From: Jason Helms [jasoncivil@alumni.nd.edu]
Sent: Thursday, May 09, 2013 5:26 AM
To: Jordan, Blake
Subject: Armstrong transfer split/deed issues
Attachments: armstrong_2011_jch_layout.pdf; armstrong_2013deed_jch_layout.pdf

I am trying to define the water right split for the Armstrong transfers to the City of Chubbuck and from my review of the county recorded surveys there is an apparent error in the water right split that occurred recently.

Howard Armstrong / Trail Creek
TWP 6S, RNG 34E, Section 28

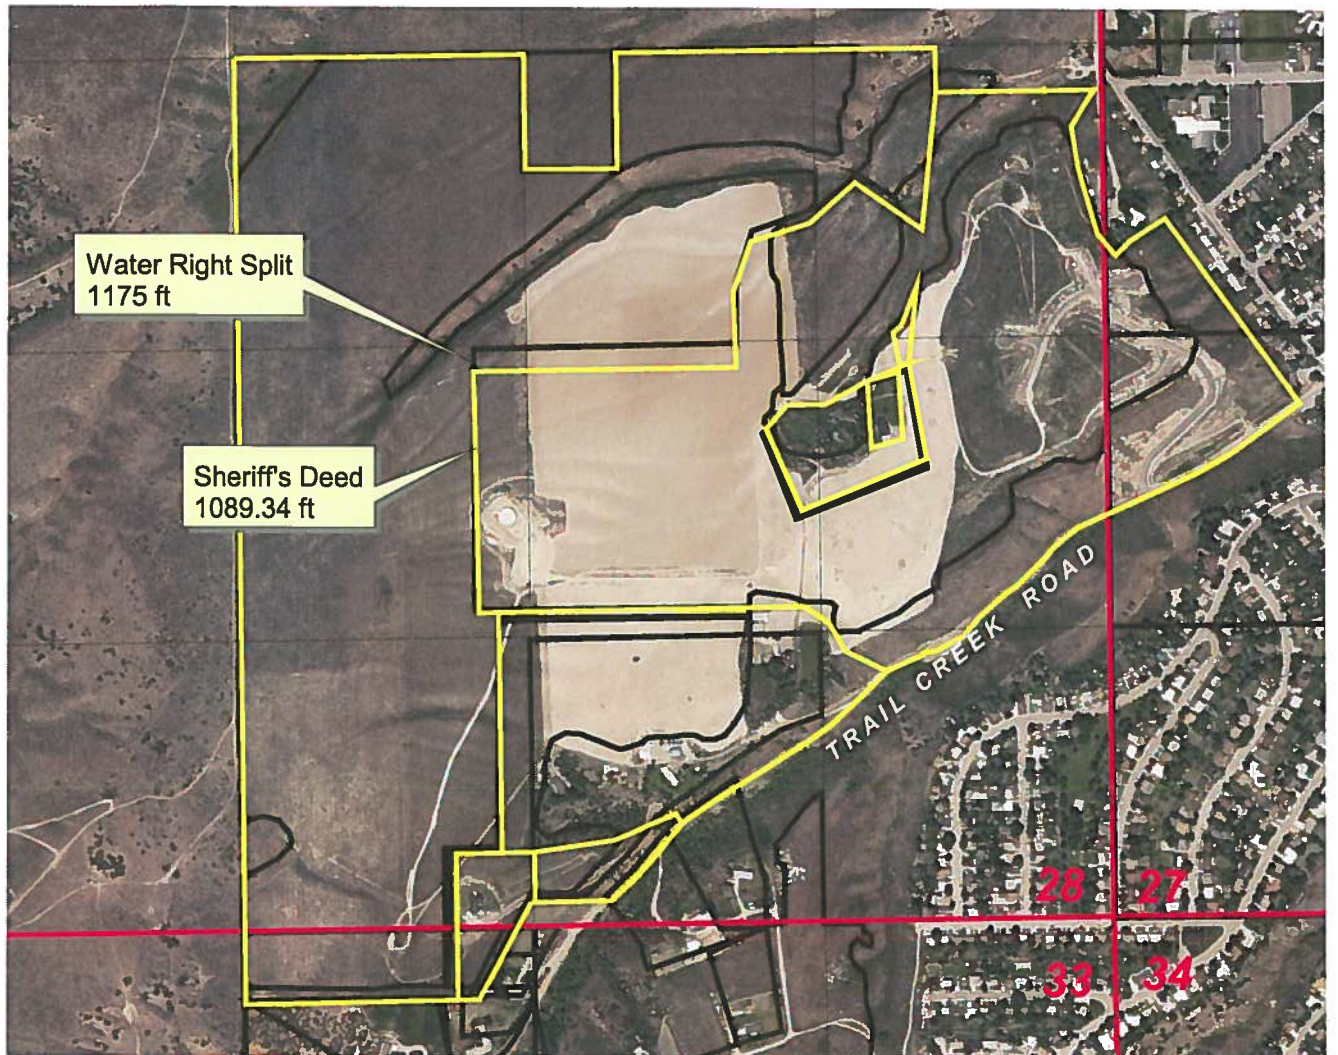
I have attached a pdf of my review from 2011 before the Trail Creek split that created 29-14054 through 29-14056 in addition to a pdf layout of my deed re-work overlay on the current water right pou. There appears to be an 80 ft error in the west line of the Trail Creek portion unless there is a deed that I am unaware of.
